ADDENDUM #2

September 14, 2026

HOCKINSON HIGH SCHOOL
JV SOFTBALL FIELD

Addendum #2 consists of information and plan revisions/additions:

BASE/HOME PLATE ASSEMBLY
N.T.S.

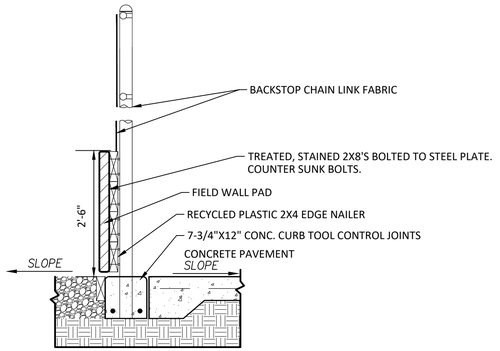
1. Base/Home Plate Assembly detail on sheet C5.02 Site Details revised.
2. Minor plan changes to the structural plans for the Building Permit Set. See sheets S2 Structural Plans and S3 Structural Details.

NOTES:
1) BASES SHALL COMPRESS UPON IMPACT.
2) PROVIDE ANCHOR PLUGS FOR EACH BASE AND DIGOUT TOOL FOR EACH FIELD.
3) PITCHING RUBBER SHALL HAVE STANCHION, ANCHOR, AND PLUG.
4) TOP OF ANCHOR TO BE SET BELOW FINISH GRADE OF INFIELD MIX.
5) HOME PLATE SHALL USE MACGREGOR MAJOR LEAGUE HOME PLATE WITH ANCHOR (OR APPROVED EQUAL)
